## Technical Review of Tree Related Issues in ACE Paper 8/2023

(Rev.2)

This Paper summarizes the findings of a Technical Review of Sections 5, 6 and 8 of ACE Paper 8/2023: Reporting of the Additional Information prepared for the EIA Report on “Technical Study on Partial Development of Fanling Golf Course – Feasibility Study”. Reference is also made where appropriate to the original Environmental Impact Assessment (EIA) Report that was uploaded for public viewing in June 2022.

Figure 8.3 – Composite Diagram of Sun Path Analysis at Hourly Intervals from Sunrise to Sunset at Summer Solstice

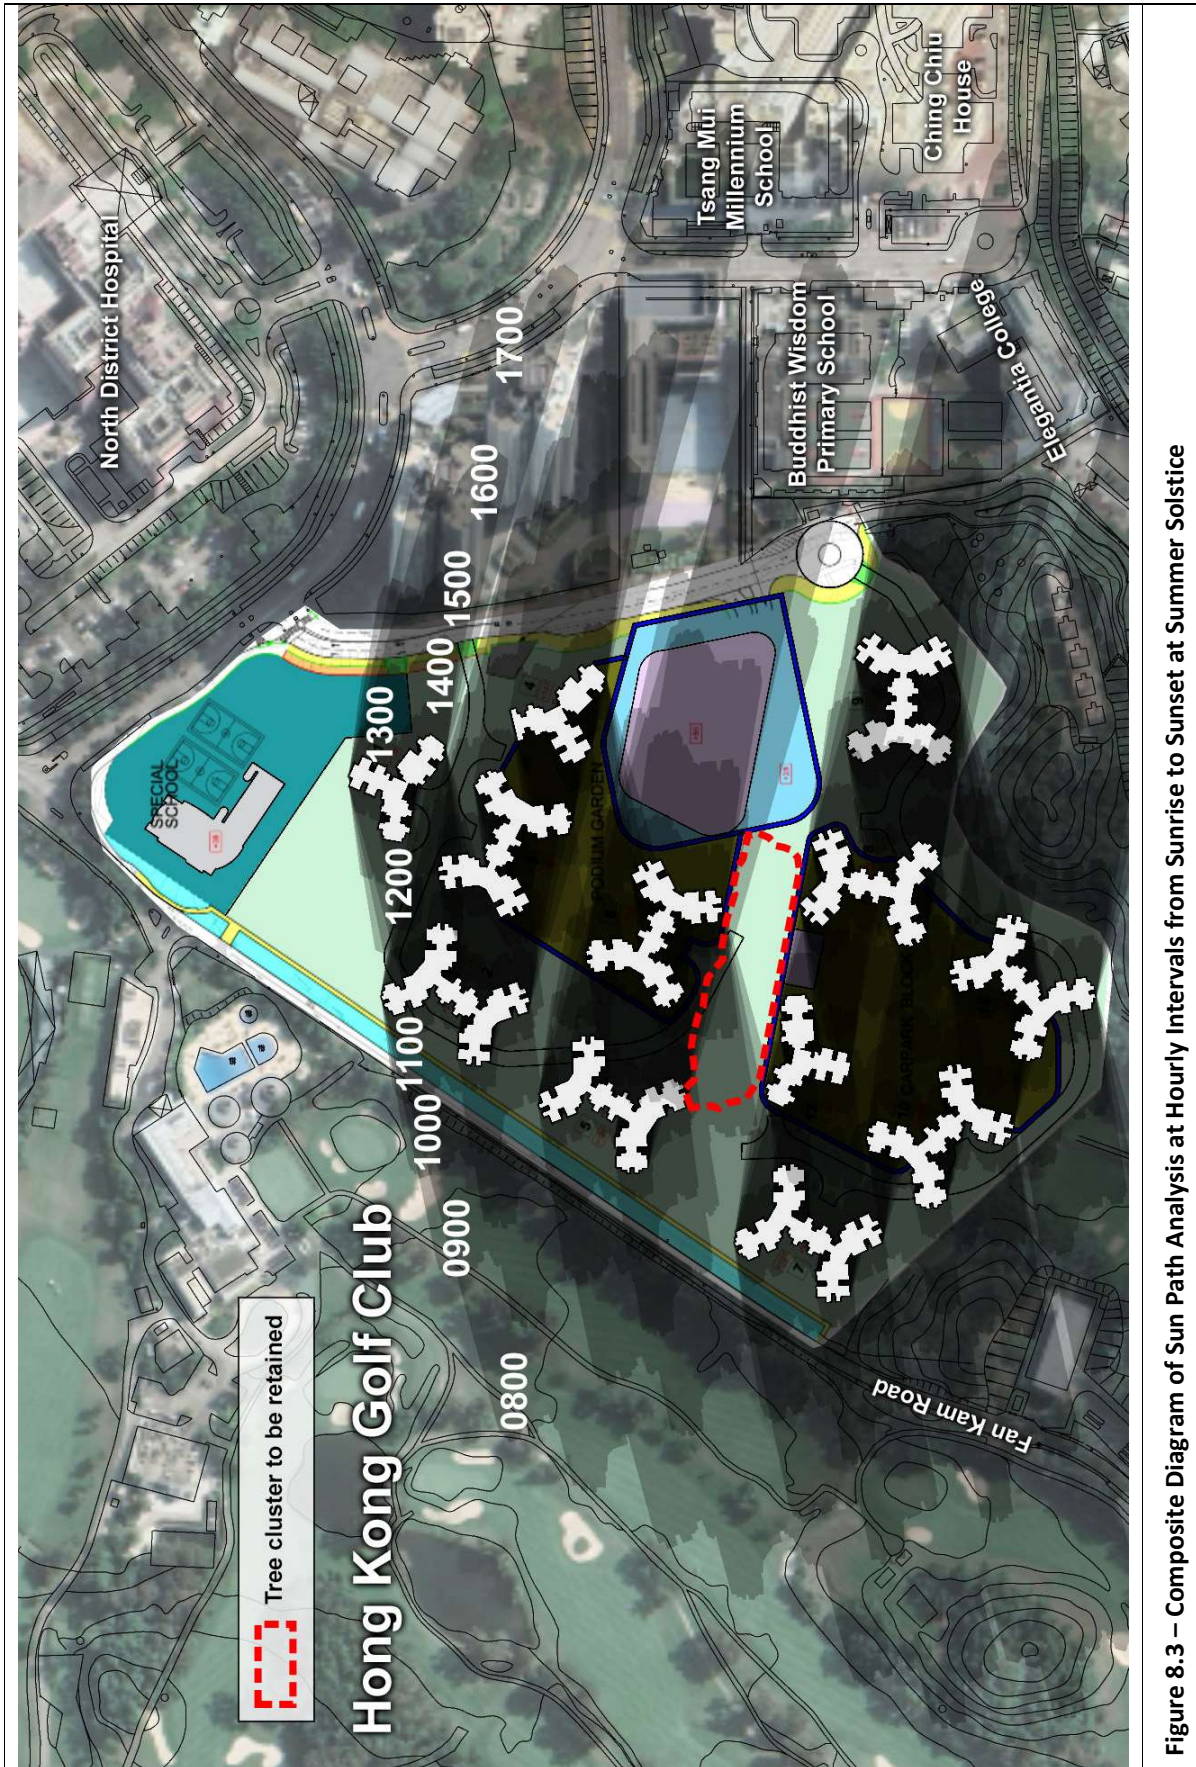
- b. **Tree Count in paragraph 8.2.2 is wrong.** Due to the poor quality of the EIA Tree Survey, the tree count in the tree cluster is incorrect.
- c. **Sun Path Analysis.** Paragraph 8.2.5 states “*In spring equinox (春分), summer equinox (夏至), autumn equinox (秋分), the retained tree clusters would be able to receive direct sunlight, although in some time of a day, the trees may be shaded by the proposed housing development. The shading is not significant.*” This statement greatly understates the actual shading that will be caused by the buildings, and it is wrong to say the shading is not significant. (Furthermore, there is also no such astronomical event as ‘summer equinox’ – the correct astronomical event is the “summer solstice” - this appears to reveal the consultant’s basic misunderstanding of the information they are trying to present.) Hourly sun-path diagrams for the Winter Solstice and the Spring and Autumn Equinoxes are provided in **Annex 1**. Composite sun-path diagrams are provided in **Figures 8.1 to 8.3**. Sun-path mpegs are also made available. It may be seen from composite diagrams in **Figures 8.1 to 8.3**, the hourly diagrams in **Annex 1** and the mpegs that the tree cluster is surrounded to the north and south by the very tall housing blocks and will receive less than 1 hour per day of sunlight at the Winter Solstice and less than 4 hours per day at the Spring and Autumn Equinoxes. This means the tree cluster will receive less than 4 hours per day of direct sunlight for more than 6 months of the year, which constitutes a very significant and serious shading effect, contrary to the claims in ACE Paper 8/2023. Other TPis which are (unrealistically) being proposed to be retained within the scheme would suffer even more shading than the tree cluster. This is a most significant change from the current situation in which all trees have direct sunlight from soon after sunrise to just before sunset. To say that the shading is not significant is quite incorrect and very misleading.
